SUBJECT: Major Development Proposal - American River Tourist Resort

Re: Submission on Development Report American River Tourist Resort, Kangaroo Island **PUBLIC COMMENT**

Subject: American River Tourist Resort - Release of Development Report for Public Comment

A view of the supposedly "degraded land" at the entrance to American River. The lodges will dot these beautiful hills.

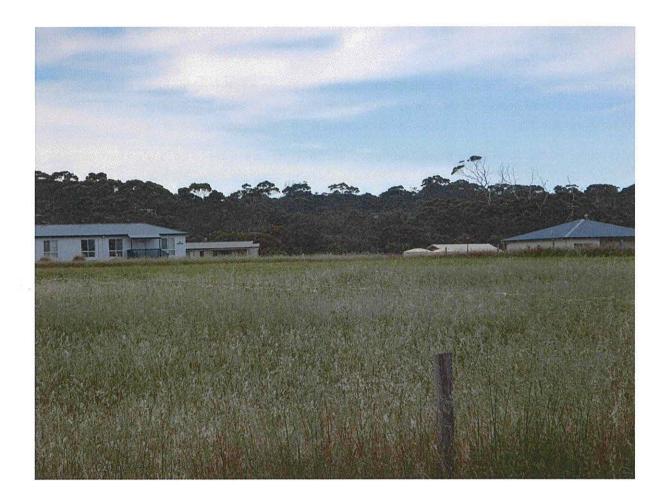
Tourism development should ensure that its scale, form and location will not overwhelm, over commercialise or detract from the intrinsic natural values of the land on which it is sited or the character of its locality.

The ten (or nine depending on which page of the DR you refer to) will completely dominate the landscape. They will definitely over commercialise the landscape.
